Rolling Meadows Substation
Construction of a New Electrical Substation
including Grading, Drainage, and Surface Improvements
El Paso County, Colorado

EPC STORMWATER REVIEW COMMENTS
IN ORANGE BOXES WITH BLACK TEXT

PPR2619

115/12.47kV
COVER SHEET

S1183-A-01-001

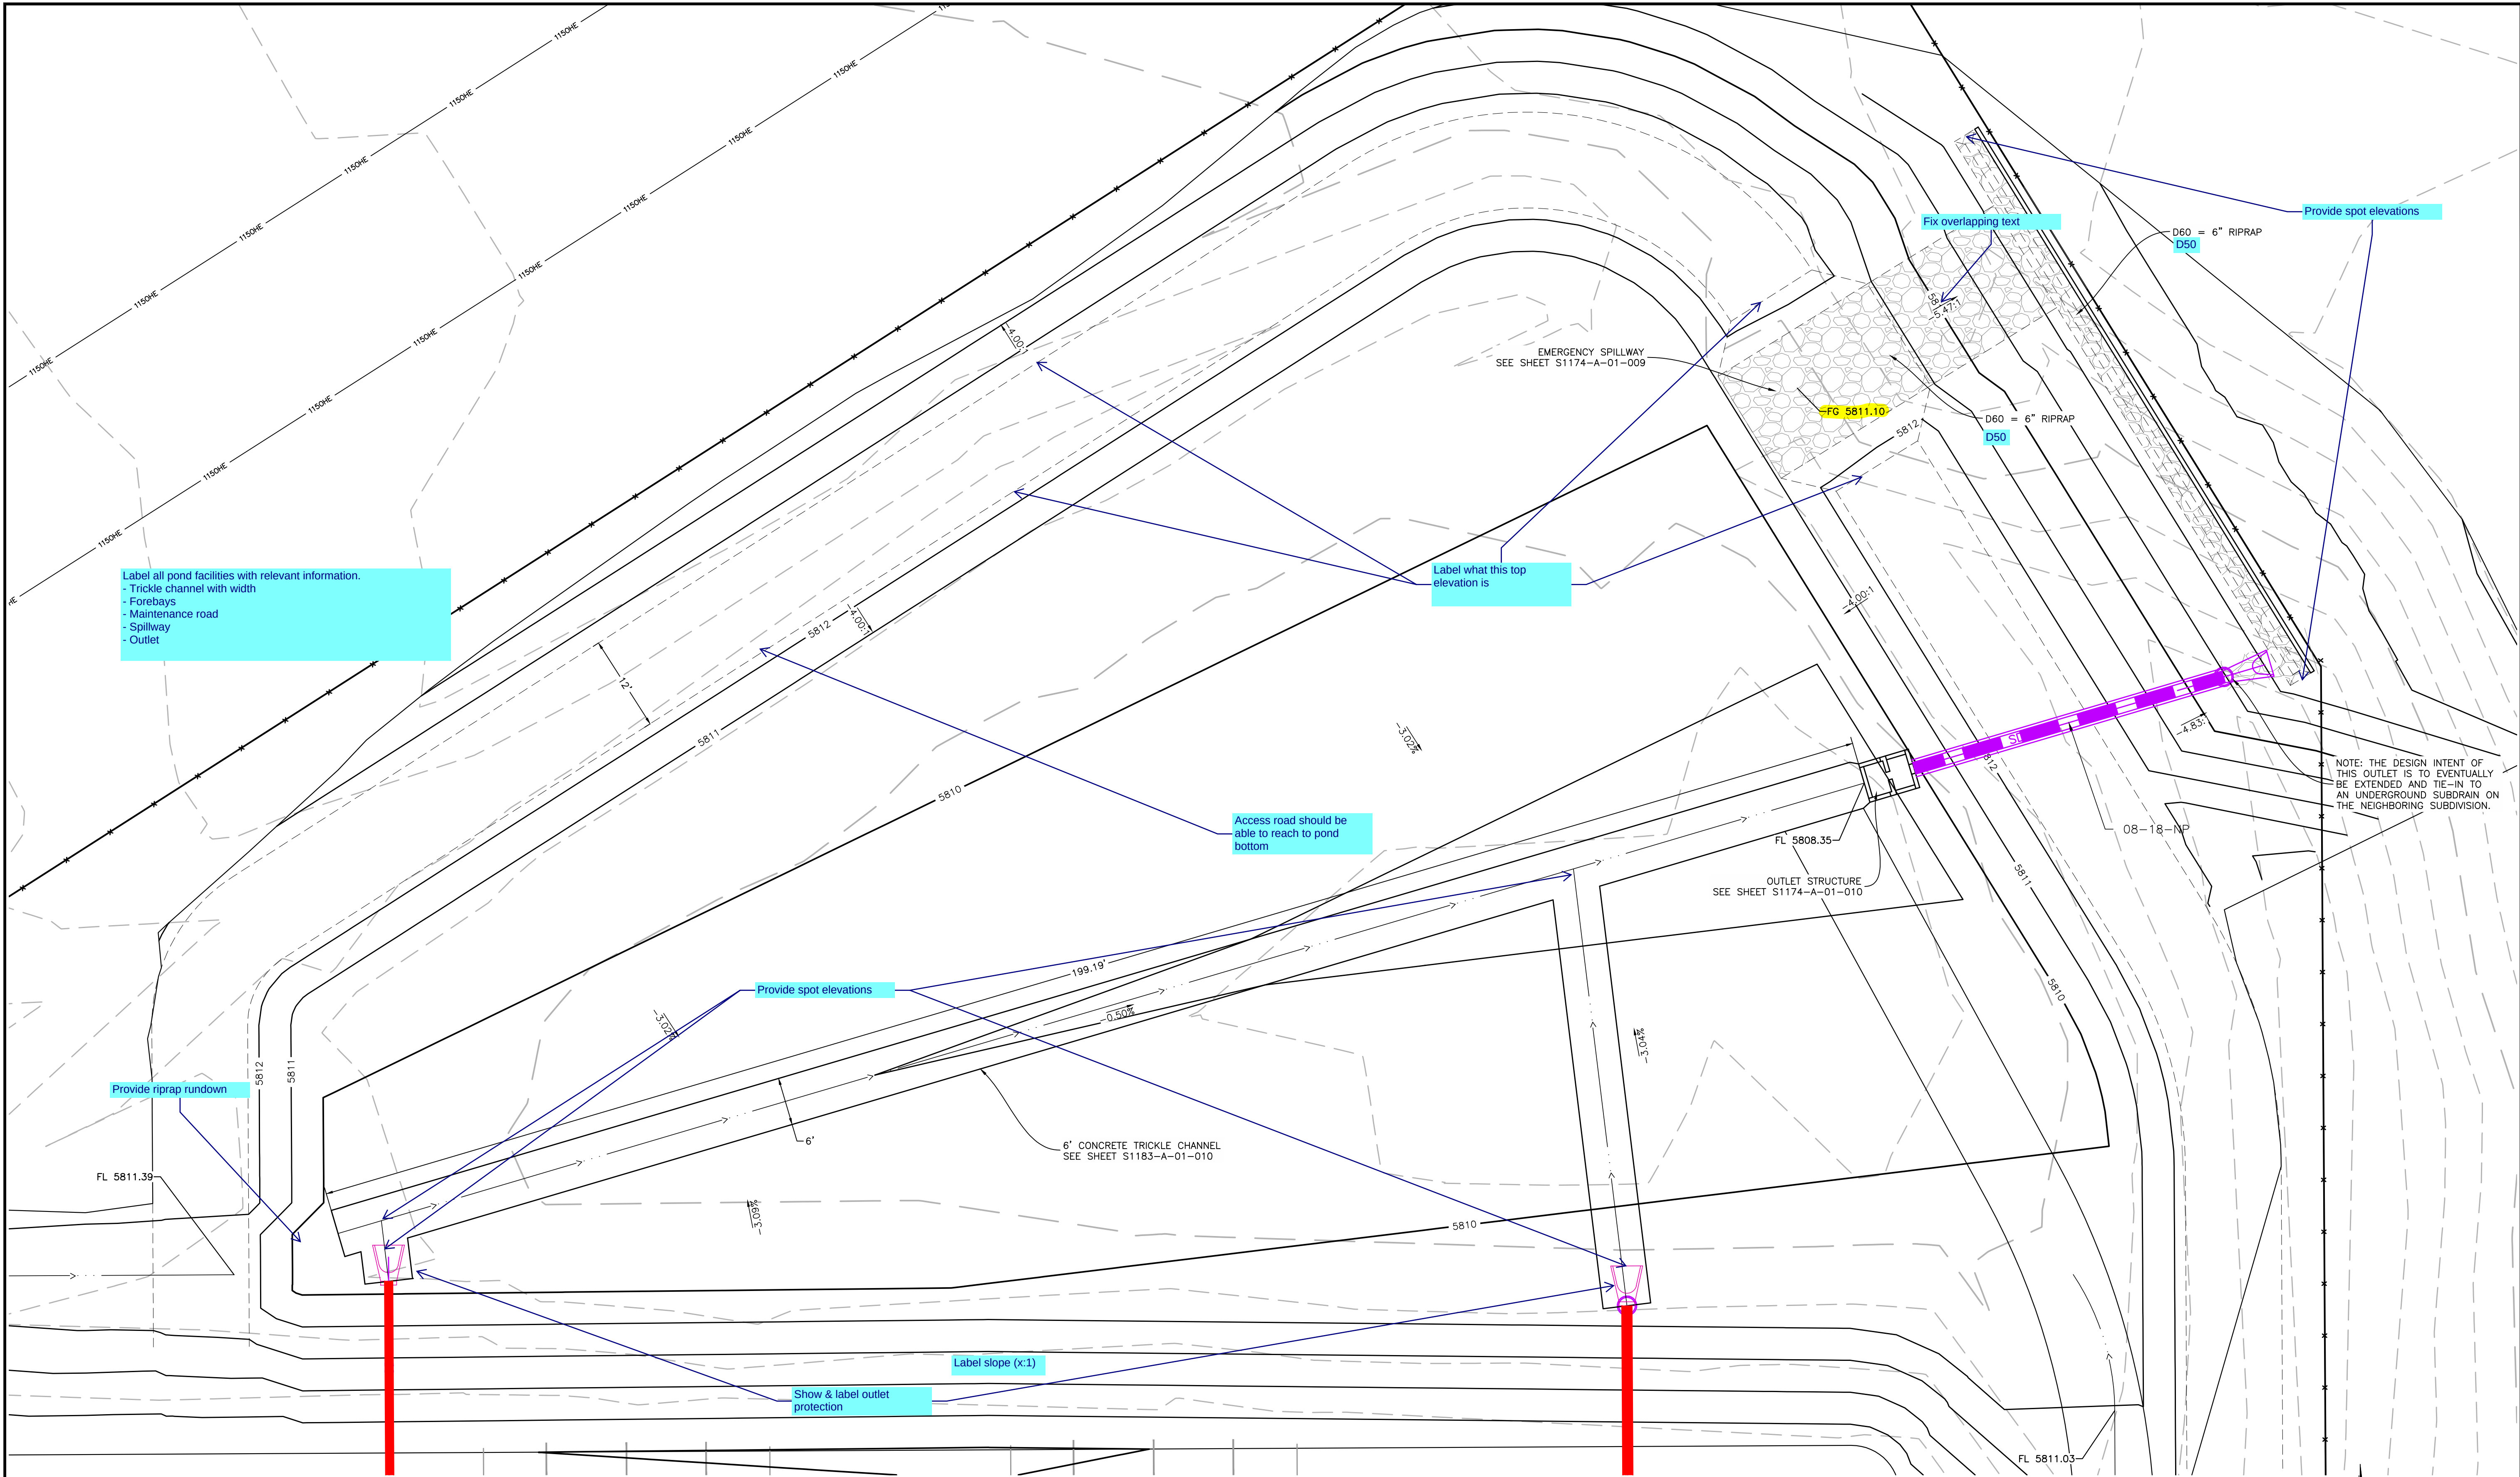
Include Sheet Index

S1183-A-01-007

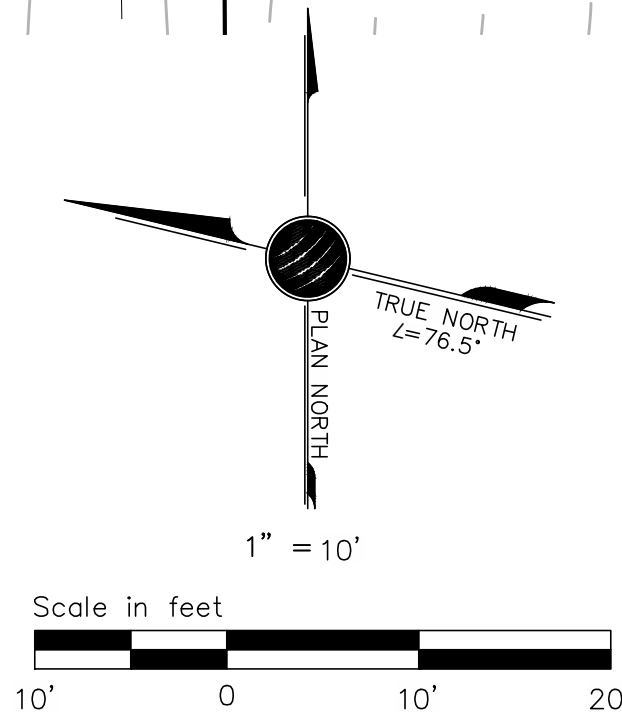
Show maintenance roadway in planview

TYPICAL DRIVEWAY SECTION
N.T.S.

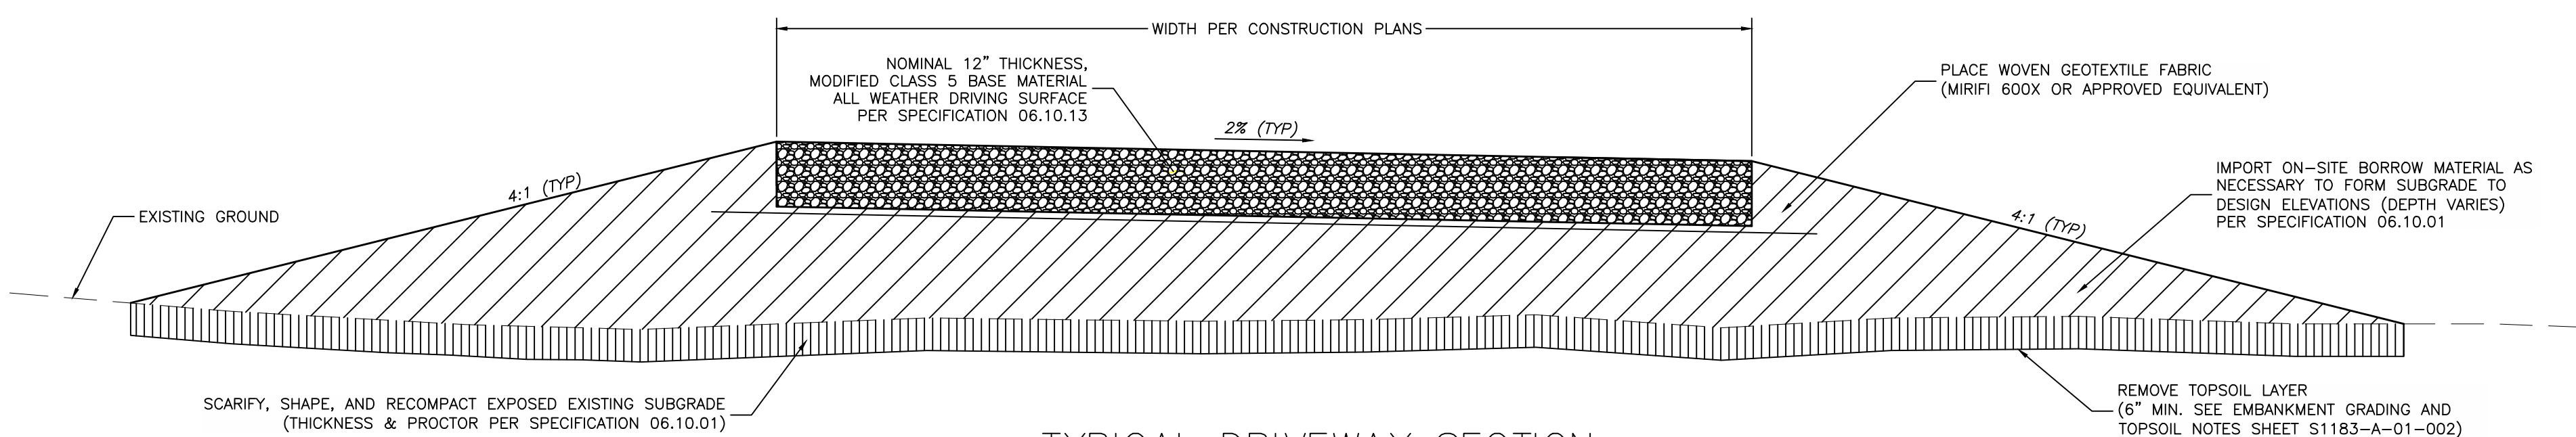
Provide driveway section for paved portion (first 50' of drive)

ORIFICE PLATE

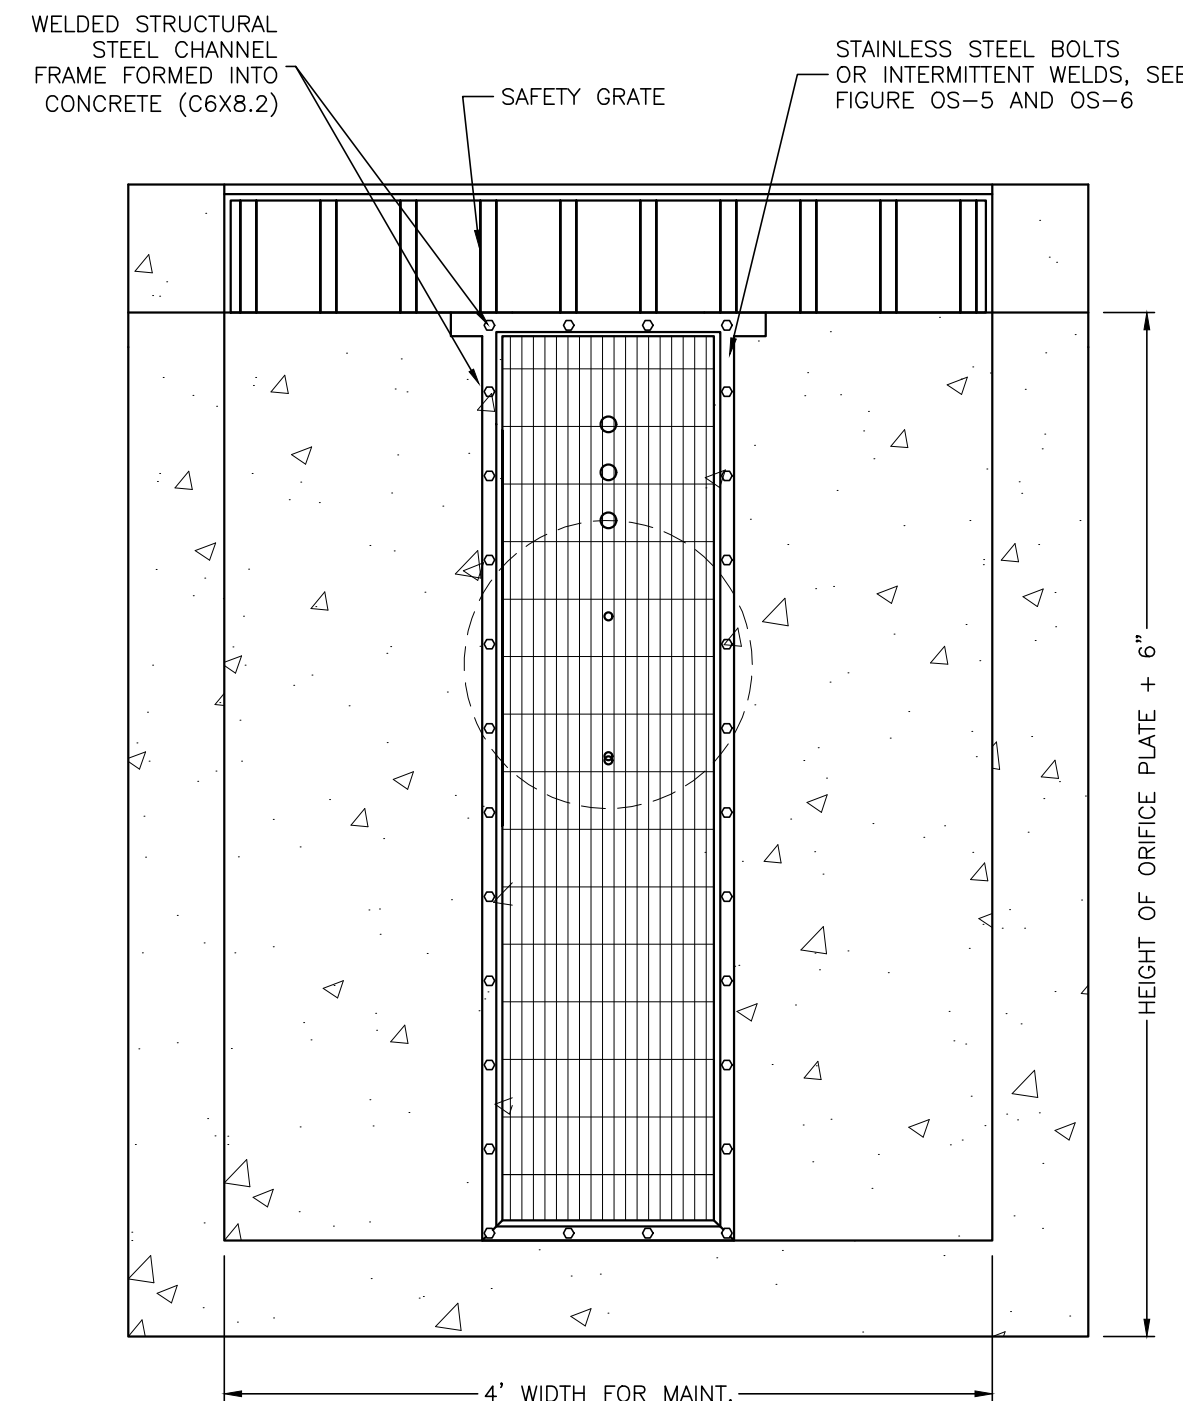
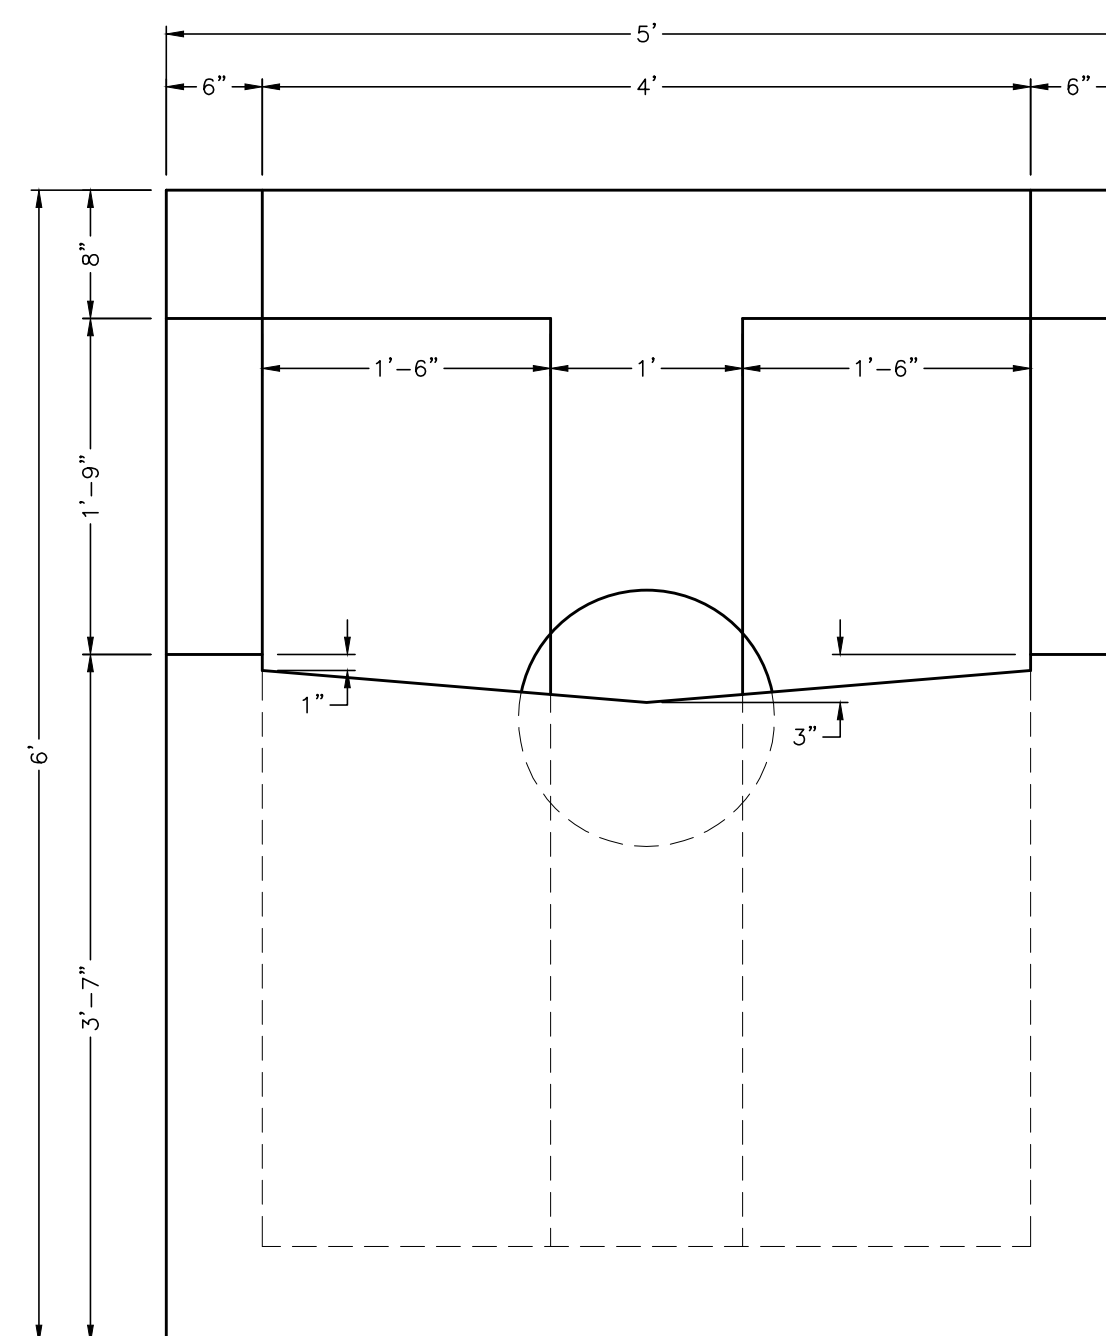
Provide restrictor plate detail.
